CITY OF NORWALK
REPORT TO THE NORWALK PLANNING COMMISSION

REQUEST:	Request from Diligent Orchard Hills, LLC to approve the Preliminary Plat of the ***Orchard Trail Plat 5***
MEETING DATE:	August 8, 2016
STAFF CONTACT:	Luke Parris, AICP City Planner
APPLICANT(S):	Diligent Orchard Hills, LLC 12119 Stratford Dr. Ste B Clive, Iowa 50325 Civil Engineering Consultants, Inc. 2400 86th St. Unit 12 Des Moines, Iowa 50322
GENERAL DESCRIPTION:	This request would create 33 lots along the continuation of the Rellim Drive stub off of West Pine Avenue
IMPACT ON NEIGHBORHOOD:	The properties surrounding the new area are single-family homes.
VEHICULAR & PEDESTRIAN TRAFFIC:	The plat shows the construction of two new streets. Rellim Drive provides a north/south street between Sycamore Drive and West Pine Avenue. The plat includes a section of Sycamore Drive that completes the development of this street, providing a connection from Orchard Hills Drive to North Avenue.
TRAIL PLAN:	The plat includes standard 5' sidewalks. A 6' trail is included on the south side of Sycamore Drive.

ORCHARD TRAIL PLAT 5

PRELIMINARY PLAT

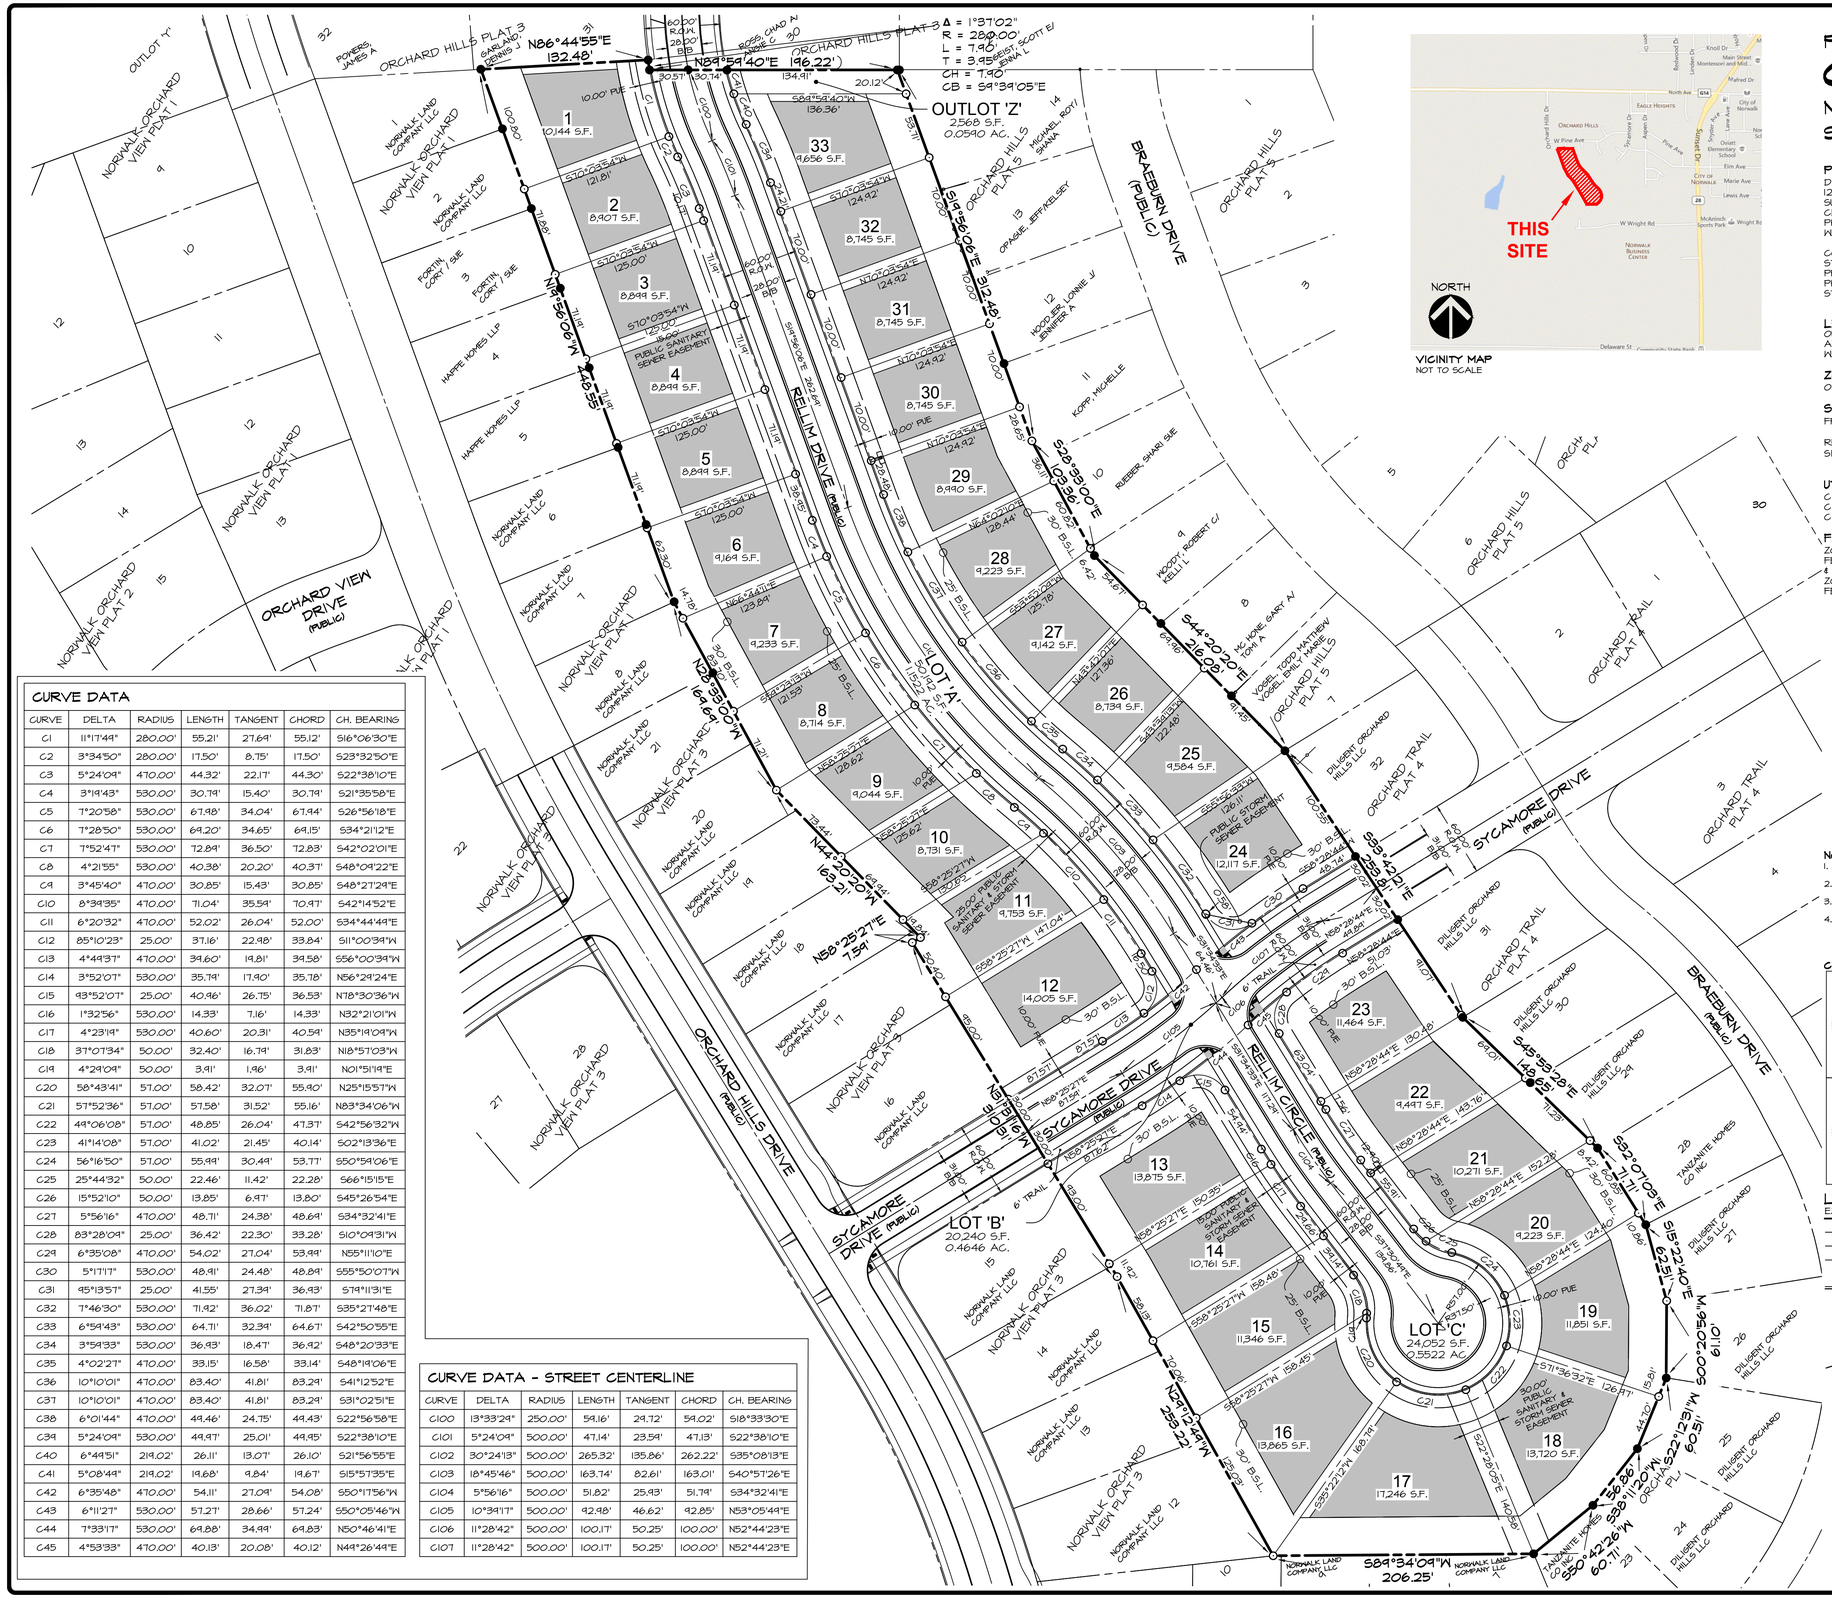
- An 8" water main is provided on the east side of Rellim and on the south side of Sycamore.
- Hydrants are shown along Rellim and Sycamore with adequate coverage .
- An 8" sanitary sewer is provided on the west side of Rellim and provides service to the 33 lots.
- A 15" storm sewer is along Rellim and connects to an 18" storm sewer that connects offsite to the south.

Streets shown will be dedicated to the City for street use upon approval of the Final Plat. The designated street right-of-way is 60 feet with a 28' wide road on Rellim and 60 feet with a 31' wide road on Sycamore.

- Minimum lot area – 7,500 SF
- Minimum lot width – 60'
- Front Setback – 25' on Rellim, 30' on Sycamore
- Side setback – 12' total (min. 5' one side)
- Rear setback – 30'
- Height – 35'

Therefore, staff recommends that the request for the Preliminary Plat of Orchard Trail Plat 5 be approved with the following conditions:

- That the applicant provides all supporting documentation required within the Norwalk Subdivision Regulations.
- That any significant modifications to the final plat be reviewed and approved by the Planning & Zoning Commission and City Council.
